SUBJECT: Baxter Addition

Re.: S/D 84-108 - Final Plat of Baxter Place Addition

Re: S/D 84-108 - Preliminary plat of Baxter Place Addition,  
located between Lewis and Waterman, east of Ellson Street.

Re: Re-Zone 11.24 Acres, "A-A" to "R-6"  
Linwood Acres, Wichita, Kansas  
Sanitary Sewer Capacity Evaluation

SITE PLAN  
 1" = 50'

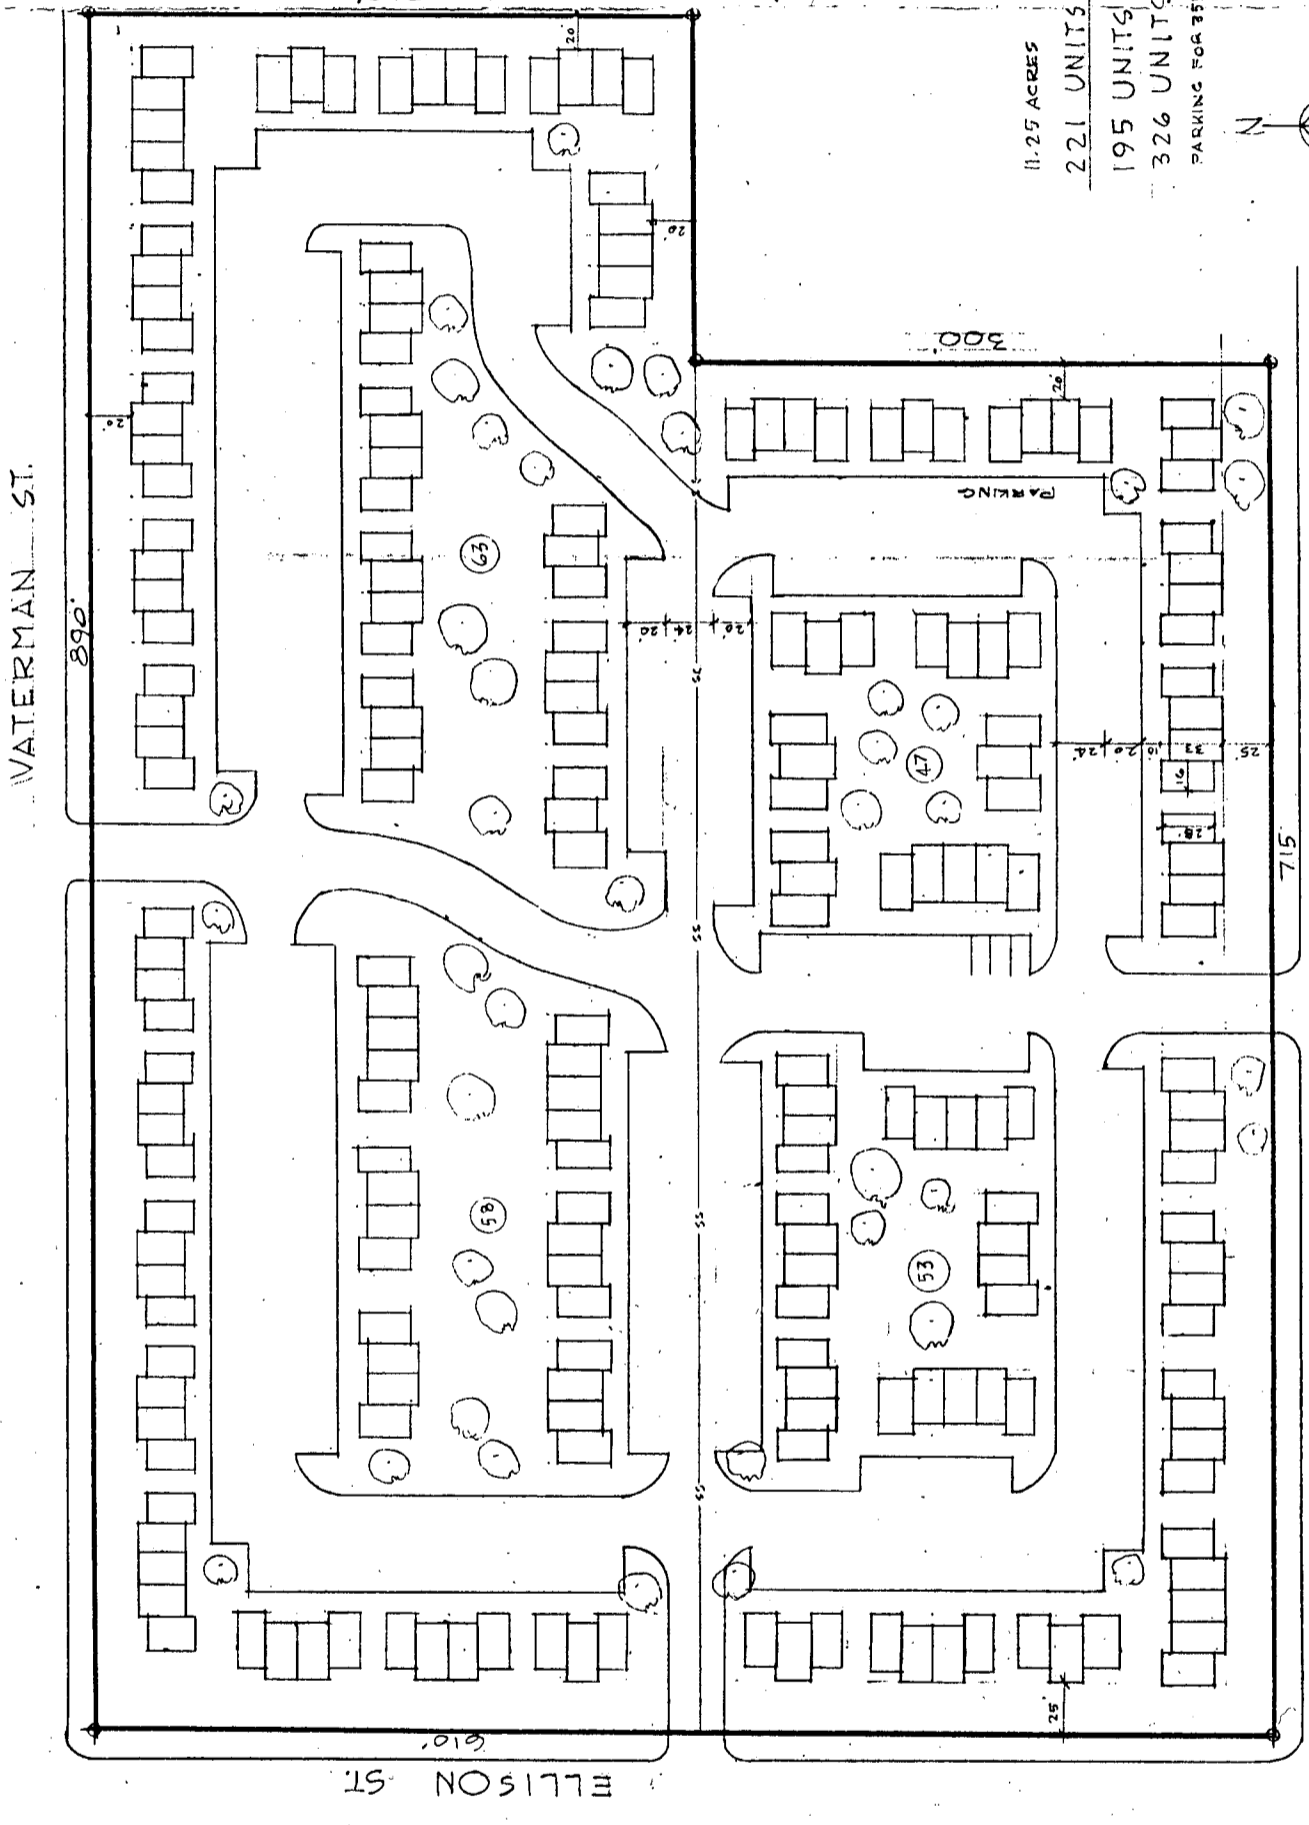
NOTE: The applicant's associated zone case (Z-2625) requesting "AA" to "R-6" has been approved subject to replatting. "R-6" zoning permits 326 dwelling units to be constructed on this one-lot plat. The applicant's site plan for this property proposes construction of 221 dwelling units with parking for 355 cars.

- A. The applicant shall submit a sidewalk certificate stating that a sidewalk will be constructed on the south side of Waterman, adjacent to this lot, at the time of site development. (Multi-family zoning.)

- B. The applicant shall guarantee the paving of Ellson and Lewis Streets. These guarantees shall provide for the construction of a sidewalk, adjacent to this lot, on the east side of Ellson and the north side of Lewis. (Multi-family zoning.)

- C. The applicant is advised that the two existing curb cuts to Waterman Street, from the northeast corner of this proposed lot, should be closed if they are not intended to be used for the redevelopment of this property.
